Access Compliance Report

Public Rights-of-Way

(Pedestrian Signals)

Intersection ID: N/A	Main Street:	Cross Street: N/A	Location: N/A
ADA ID: E7F722577C94	Signal Type: One Push Button-Non APS	Overall Compliance: No	Severity Score: BTN 1: N/A BTN 2: N/A No BTN: N/A
Codes/Mitigation Info/Possible Solution		Field Measurements/Component Compliance

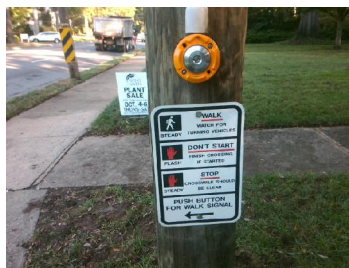
PROW/ADA: TMUTCD 4e.08, R404.3, R404.1, R404.7.1, R404.7.2

Yes	B 1 Clear Xing Direction?	ClearlyMarked	N/A	B 2 Clear Xing Direction?	N/A
	B 1 Crossing Direction	To SW		B 2 Crossing Direction	N/A
Yes	B 1 DistanceTo XWalk (in)	0.0	N/A	B 2 DistanceTo XWalk (in)	N/A
No	B 1 DistanceTo Curb (in)	84.0	N/A	B 2 DistanceTo Curb (in)	N/A
Yes	B 1 Diameter (in)	2.0	N/A	B 2 Diameter (in)	N/A

Possible Solutions: Replace Signal Push Button With APS Button on New Post. Remove & Relocate Sign.
